DOCUMENT NUMBER: 17-00181
ISSUE NUMBER: 1
ISSUE DATE: February, '98

Ripple or oscillations on 8571 'B' rail

Figure 1. Location of PCBs

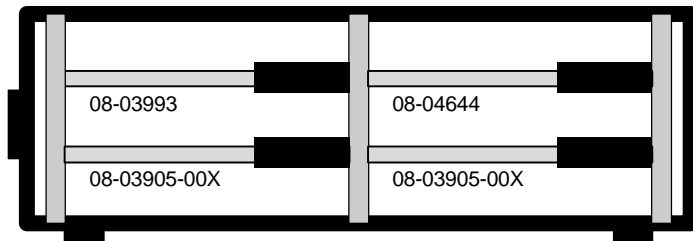
- ❑ Locate and remove the 08-03095-00X PCB(s) and the 08-03993 PCB from the unit. Refer to Figure 1.

Figure 2. Location of C6 and C31

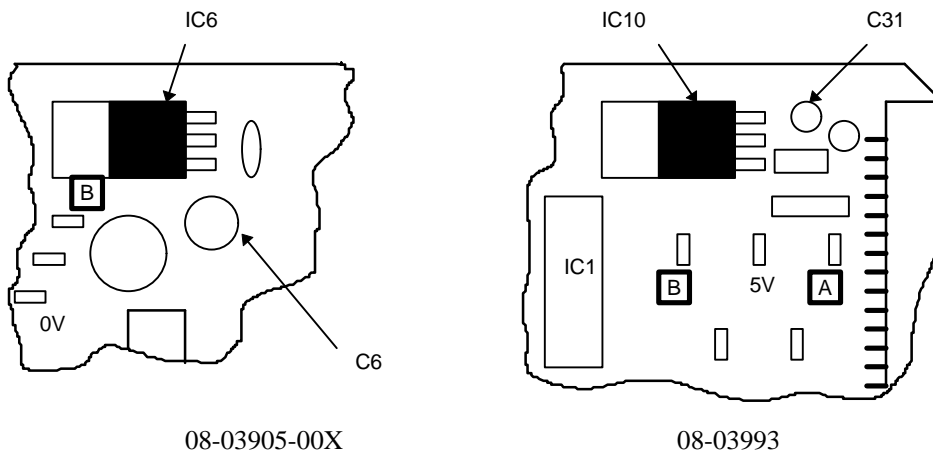
The cause is insufficient capacitance on the output of the 10 volt regulators which provide the 'B' rail of both the Microprocessor and Transceiver Interface PCB (08-03993) and the Dual Line Equaliser PCB (08-03905-00X).

The value of the capacitors on the 'B' rail of all identified PCBs should be changed to 10 μ F.

- ❑ Remove C6 and C31 and replace them with 10 μ F capacitors.
- ❑ Reinstall the PCBs ensuring they go in the correct positions. Refer to Figure 1.
